ADDENDUM NO. 2

**Three Rivers Community Schools – Three Rivers Middle School Additions and
Renovation**

SHEET CLARIFICATIONS / REVISIONS

UNIT 'B' FIRST FLOOR FINISH PLAN
1/8" = 1'-0"

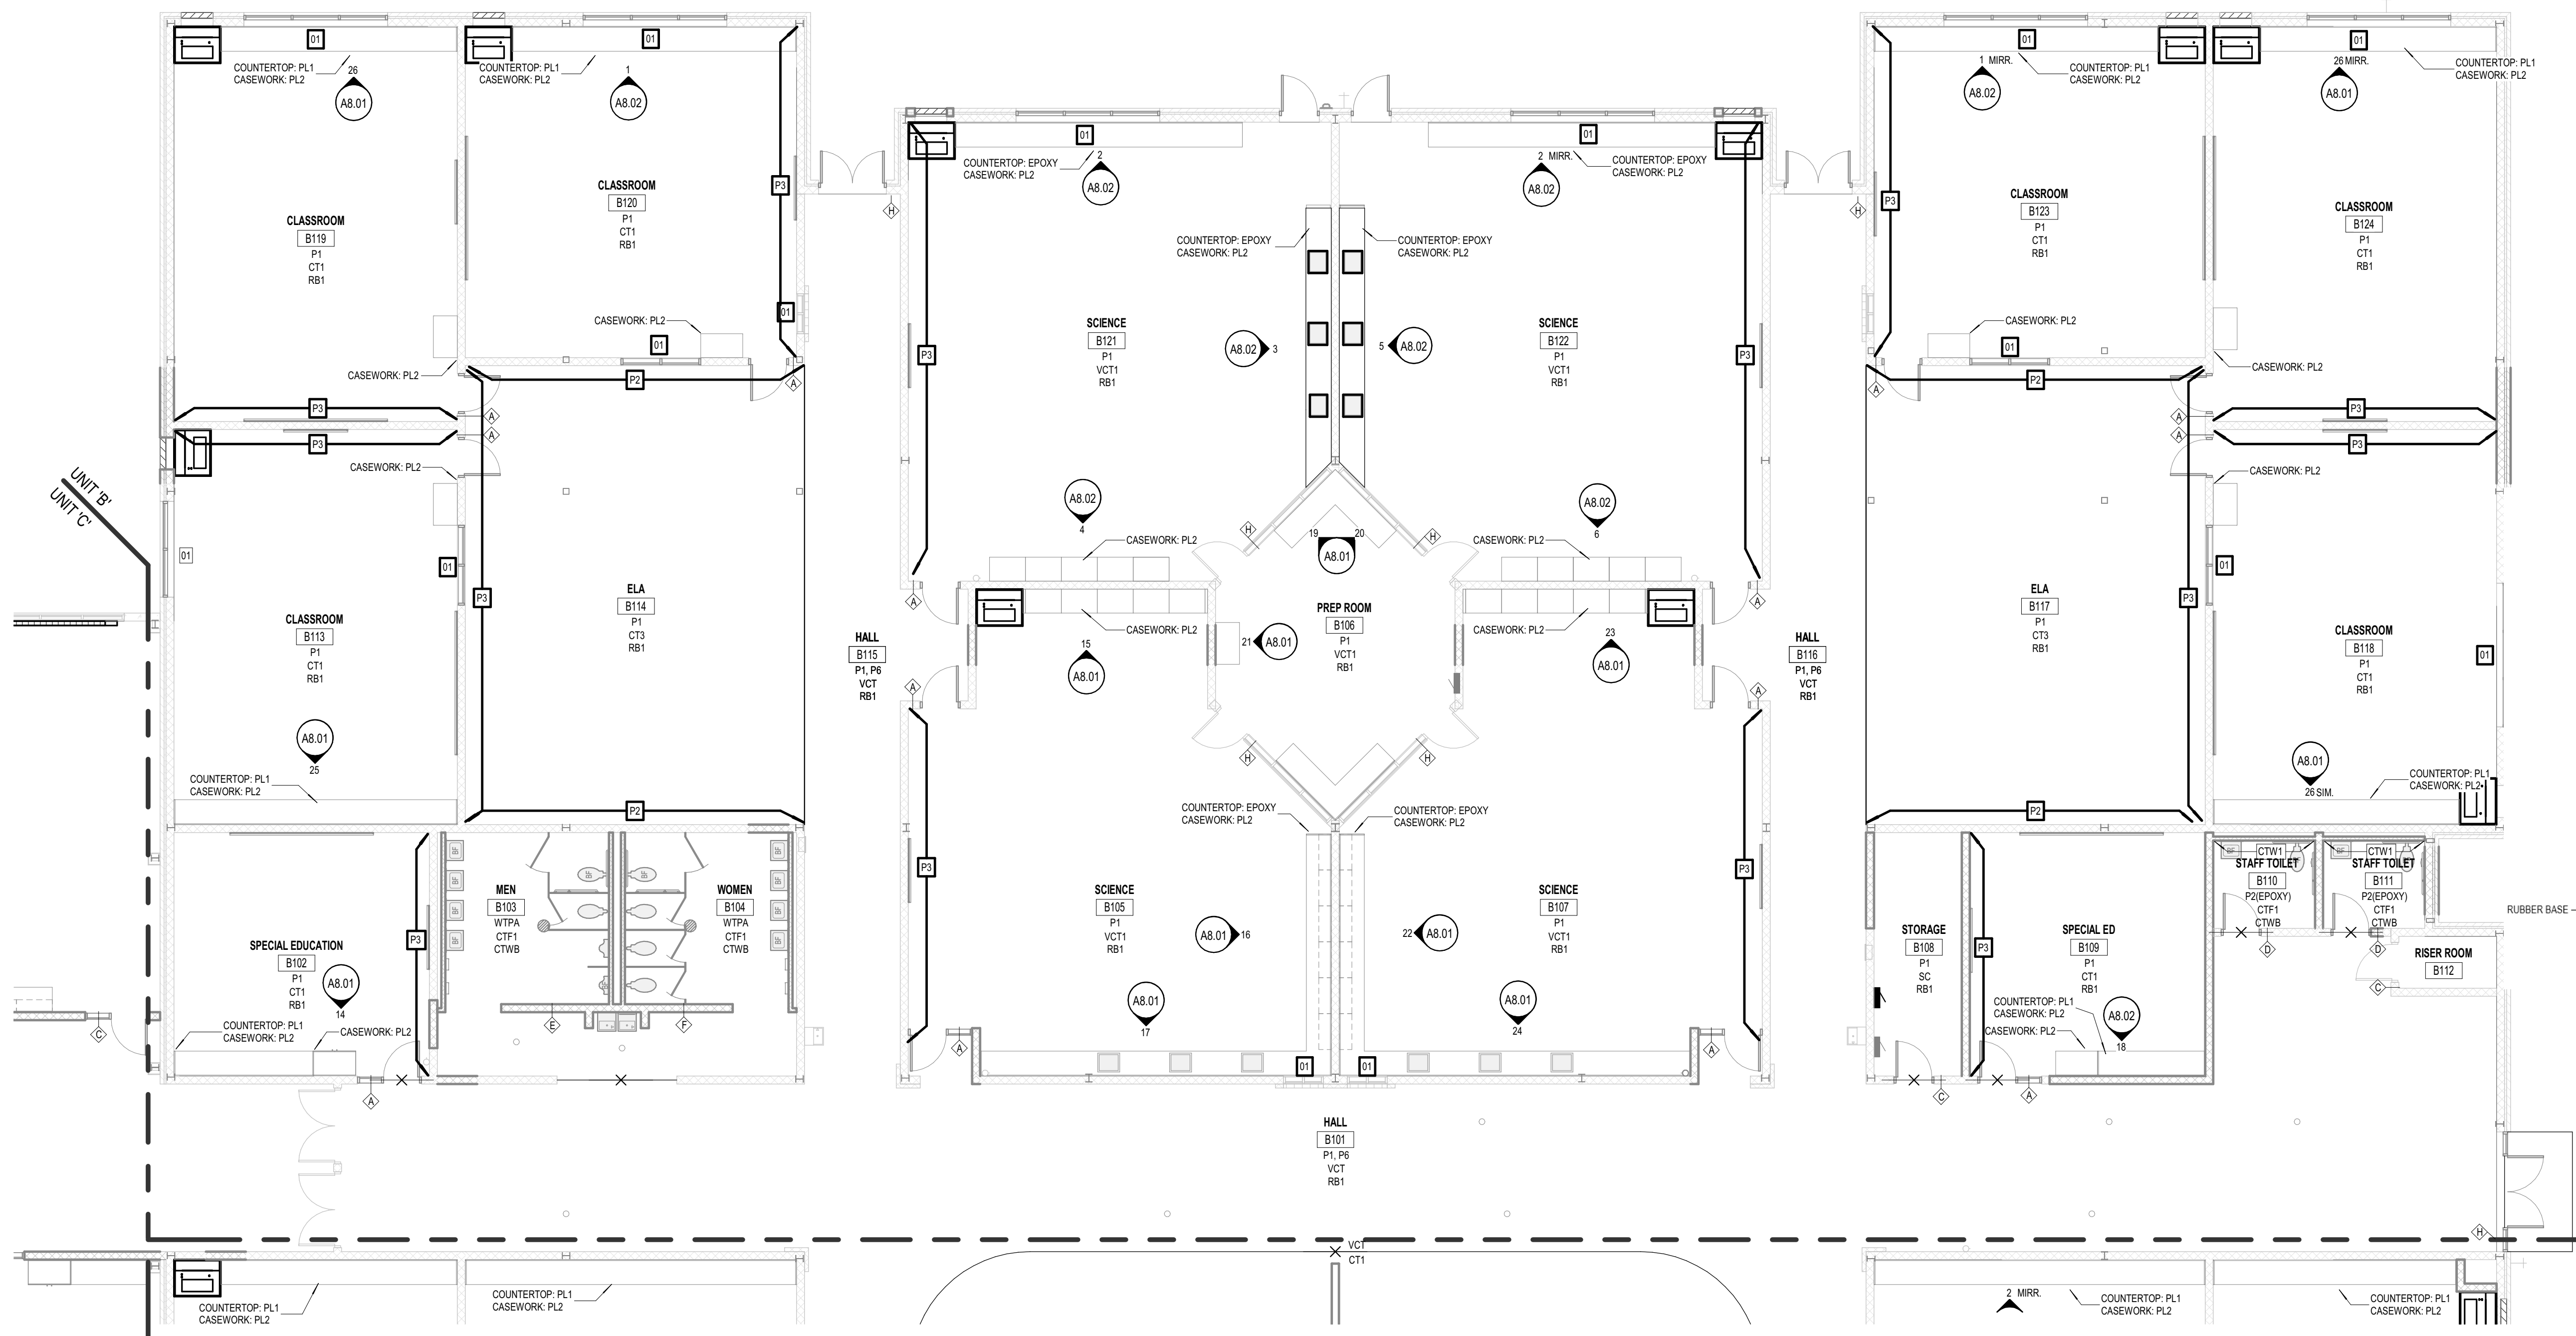
ITEM NO. 26 SHEET A9.1B – UNIT ‘B’ FIRST FLOOR FINISH PLAN (REISSUED)

Edited note 9 and added note 27.

UNIT 'C' FIRST FLOOR FINISH PLAN
1/8" = 1'-0"

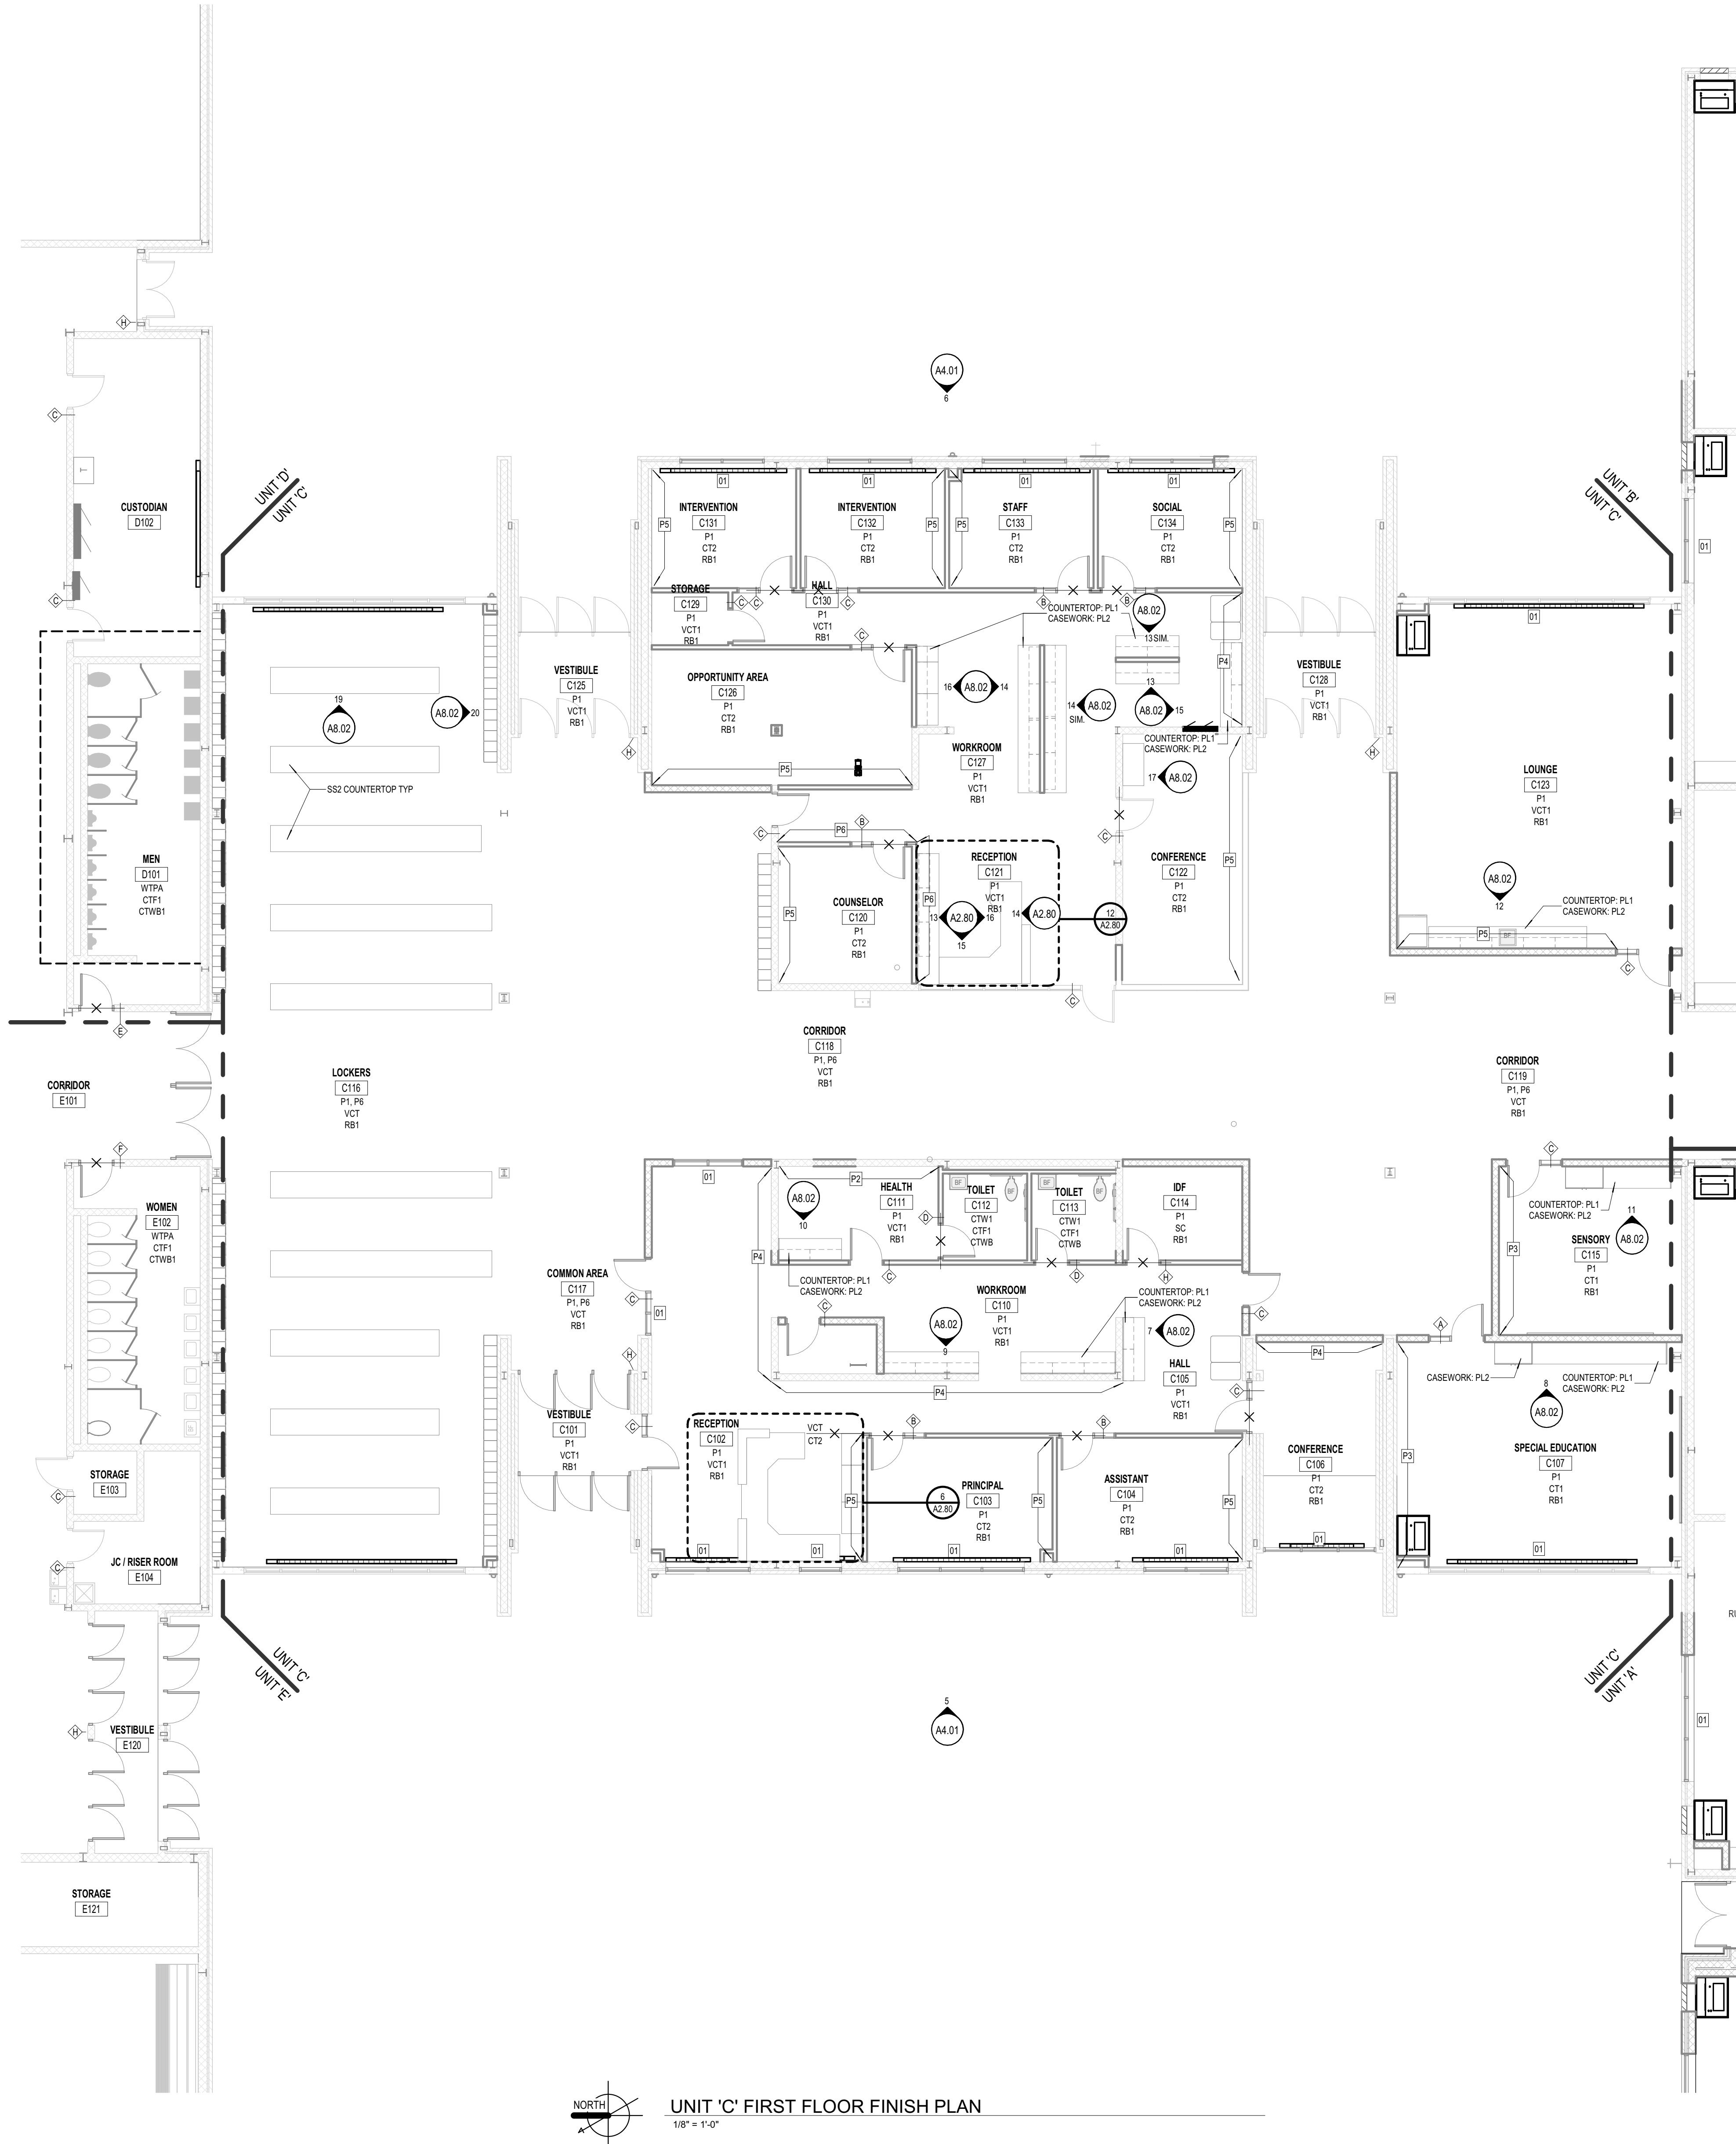
ITEM NO. 27 SHEET A9.1C – UNIT ‘C’ FIRST FLOOR FINISH PLAN (REISSUED)

Edited note 9 and added note 27.

UNIT 'D' MECHANICAL DEMOLITION PLAN
1/8" = 1'-0"

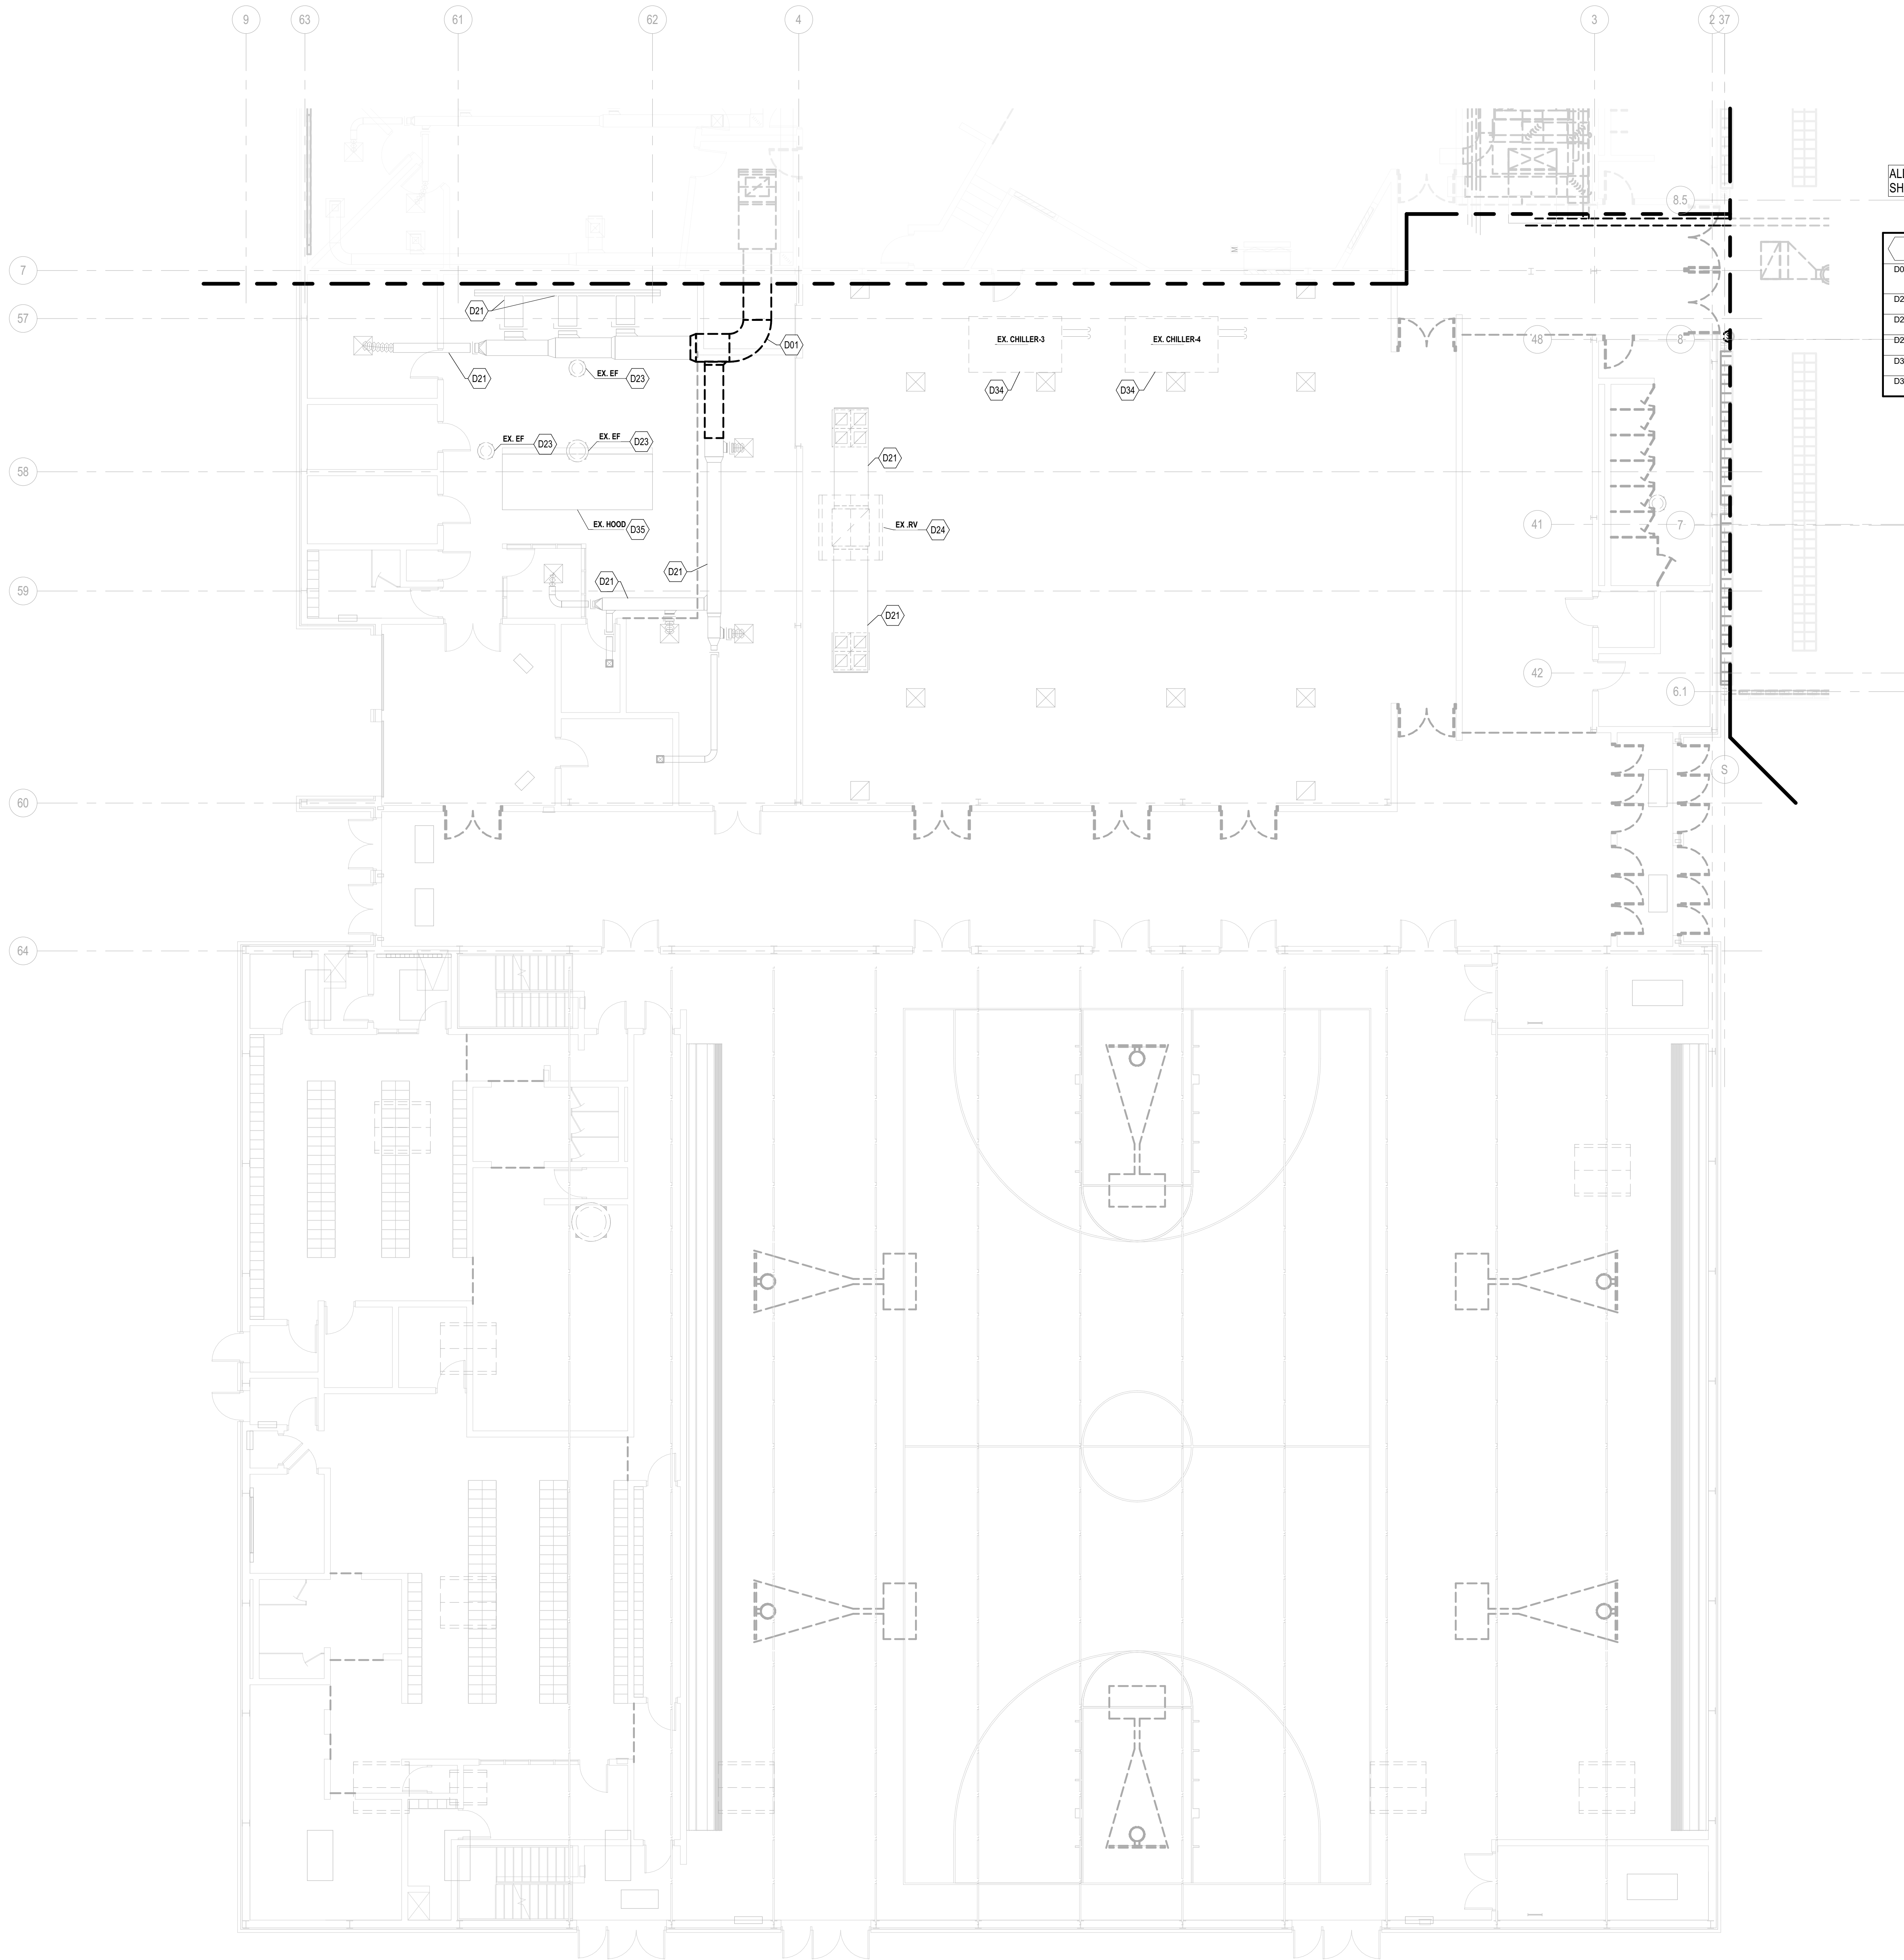
ITEM NO. 31 **SHEET M1.1D UNIT 'D' MECHANICAL DEMOLITION PLAN (REISSUED)**

- A. Added and revised mechanical keynotes.
- B. Revised Mechanical Demo Keynote Legend
- C. Added demolition of electric cabinet unit heaters, dust collection system and paint spray booth.
- D. Added general note to describe Base Bid and Alternate M-1 work in Unit D.
